LU DLUM FIRST ADDITION TO SEDGWICK COUNTY, KANSAS

RE: S/D 00-01 -- One-Step Final Plat of LUDLUM FIRST ADDITION

RE: S/D 00-01 -- One-Step Final Plat of LUDLUM FIRST ADDITION

CASE NUMBER: S/D 00-01 -- LUDLUM 1ST ADDITION

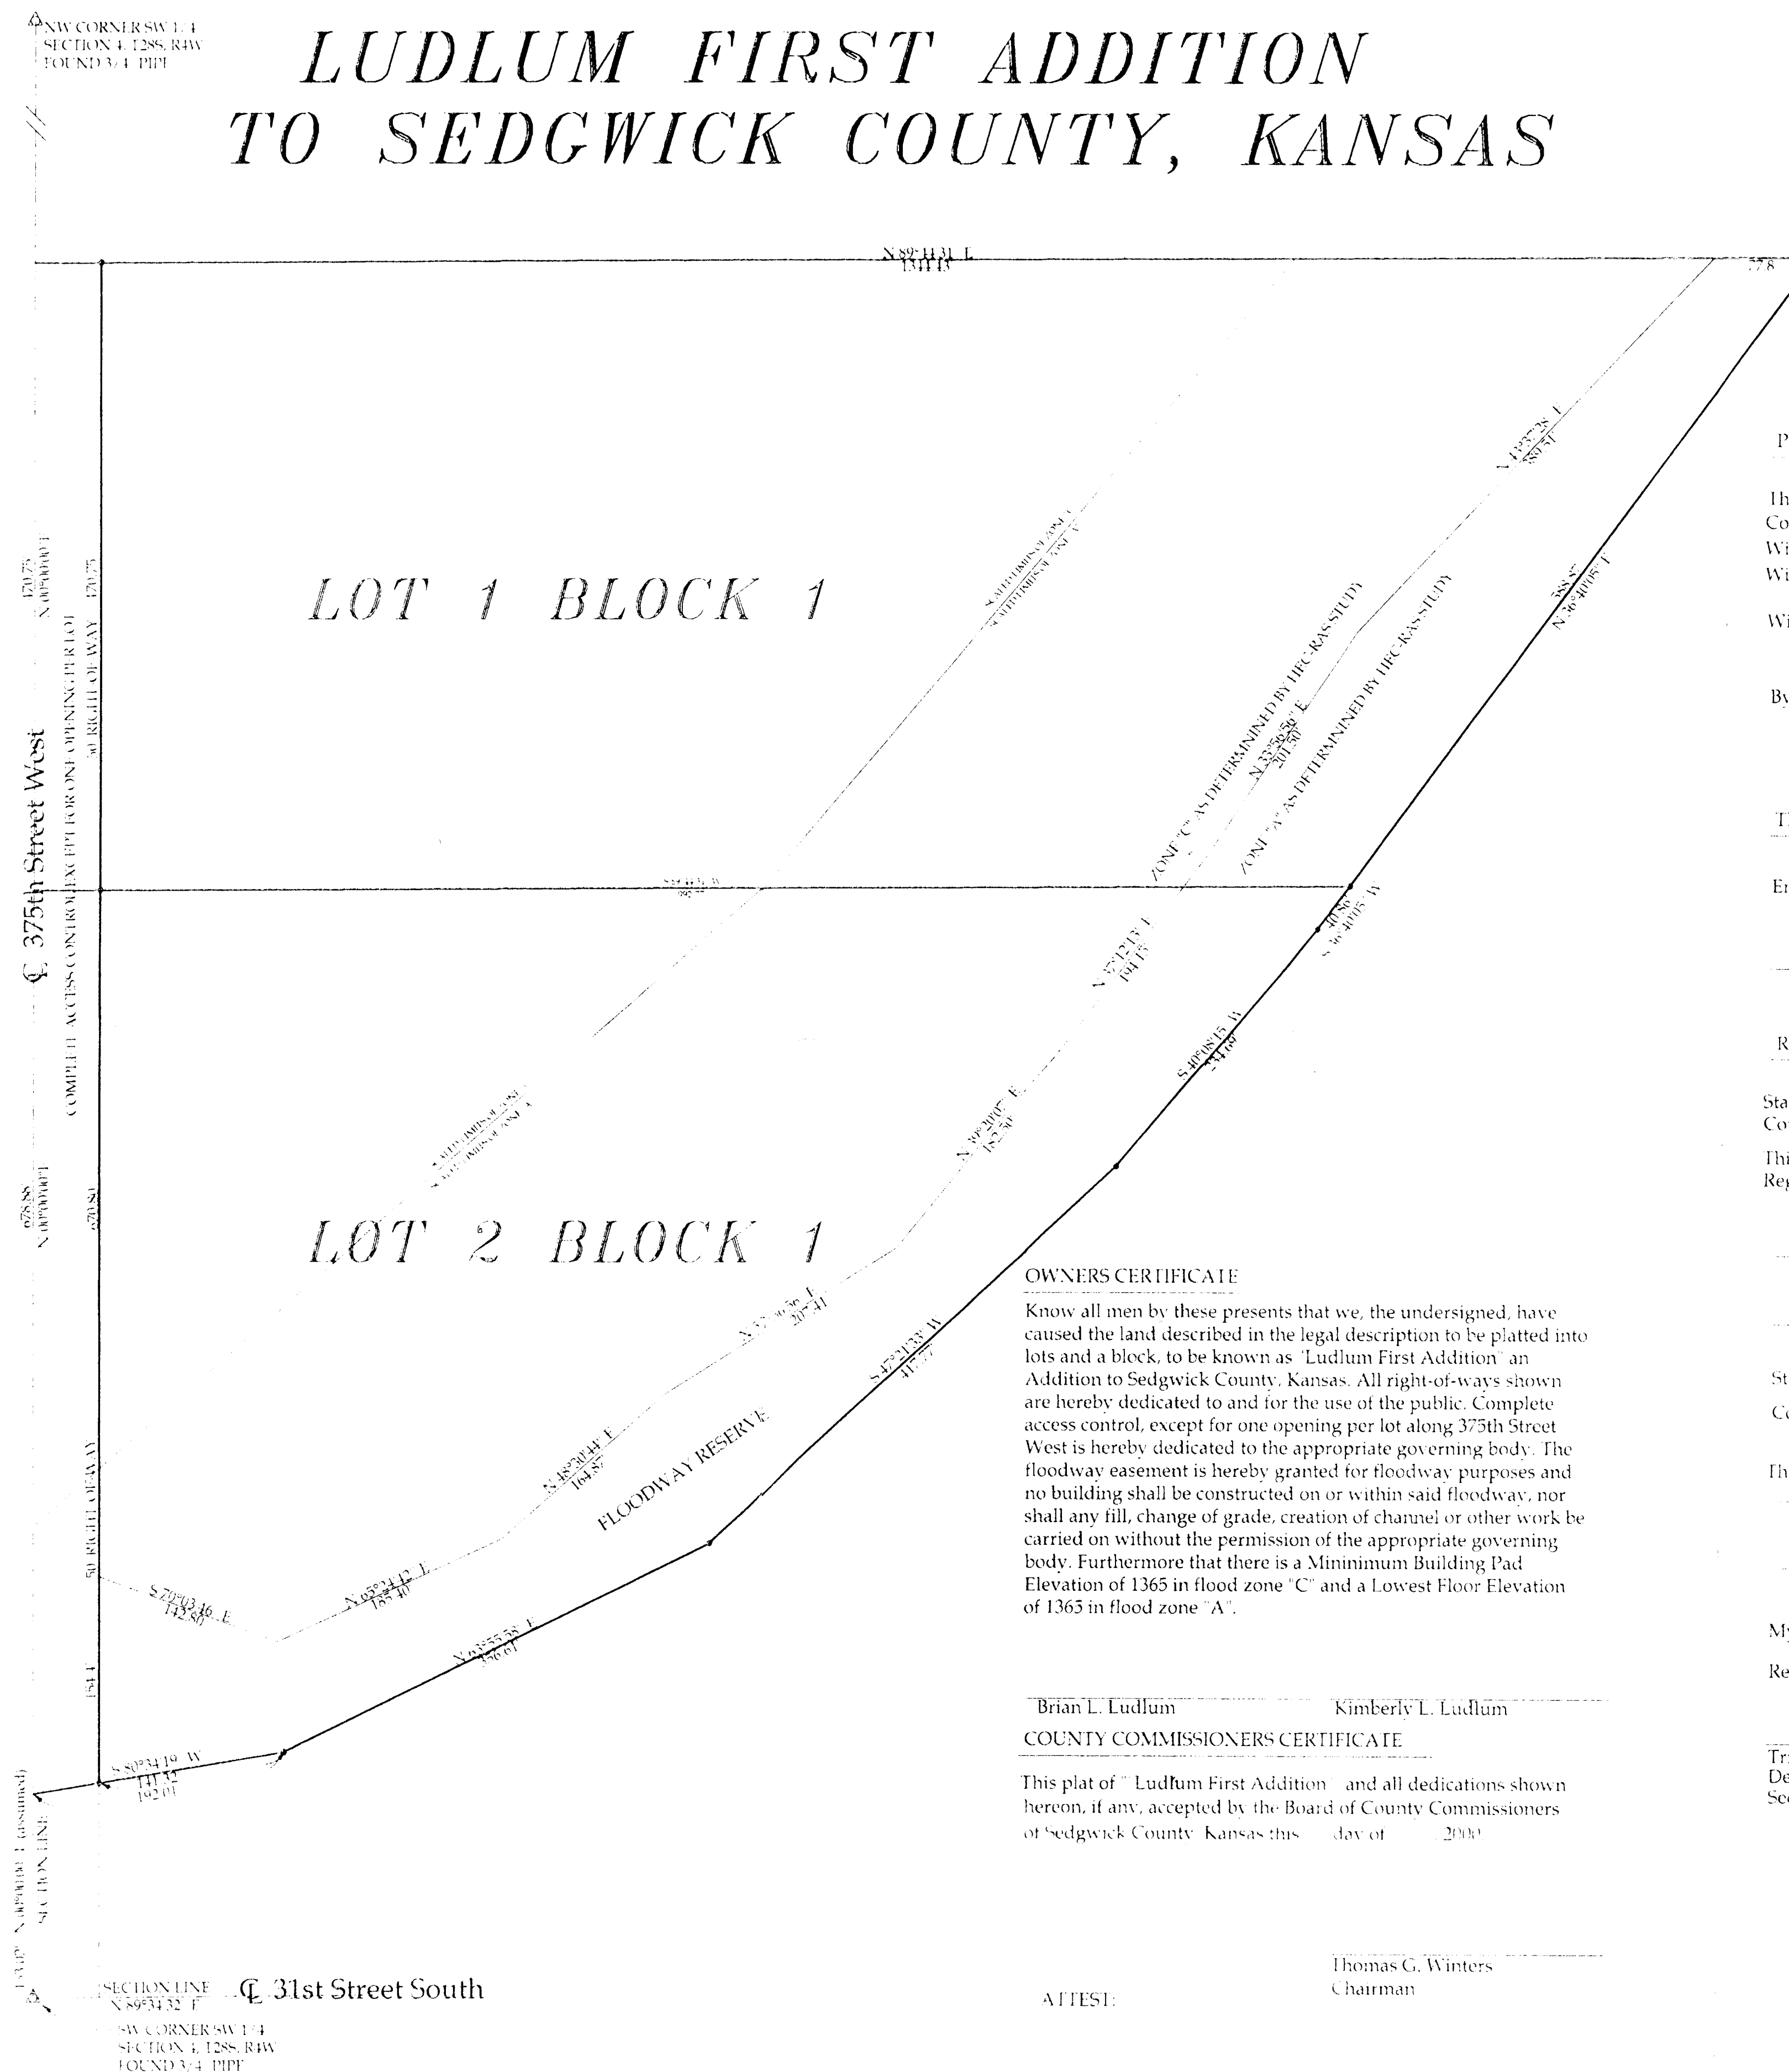
- D. **County Engineering** needs to comment on the status of the applicant's drainage plan. **The Floodway easement needs to be relabeled as a Floodway Reserve. The limits of the Floodway Reserve need to be labeled and dimensioned. The lowest floor or minimum building elevations need to be established as applicable. A HEC Quick-2 flood study run needs to be completed; which may require the revision of the floodway boundaries. A floodway reserve easement needs to be provided.**

- E. The plat proposes one access opening per lot along 375th St. West. The platlor's text shall reference "one opening per lot" and denote access controls as being dedicated to the appropriate governing body.

- F. Lot line dimensions need to be revised for the north and south lines of Lot 1 and along the southerly line of Lot 2.
- G. The owner's certificate shall reference the language "platted into lots" and include a signature line.

- M. The MAPC signature block should be revised to reference "Francis S. Garofalo" as the MAPC Chairman.
- N. The legal description needs to be revised to accurately portray the land being platted. The distances on the drawing need to correspond with those denoted within the legal description.

- D. County Engineering needs to comment on the status of the applicant's drainage plan. The Floodway easement needs to be relabeled as a Floodway Reserve. The limits of the Floodway Reserve need to be labeled and dimensioned. The lowest floor or minimum building elevations need to be established as applicable. A HEC Quick-2 flood study run needs to be completed; which may require the revision of the floodway boundaries. A floodway reserve easement needs to be provided.

- E. The plat proposes one access opening per lot along 375th St. West. The plat's text shall reference "one opening per lot" and denote access controls as being dedicated to the appropriate governing body.

- F. Lot line dimensions need to be revised for the north and south lines of Lot 1 and along the southerly line of Lot 2.
- G. The owner's certificate shall reference the language "platted into lots" and include a signature line.

- N. The legal description needs to be revised to accurately portray the land being platted. The distances on the drawing need to correspond with those denoted within the legal description.
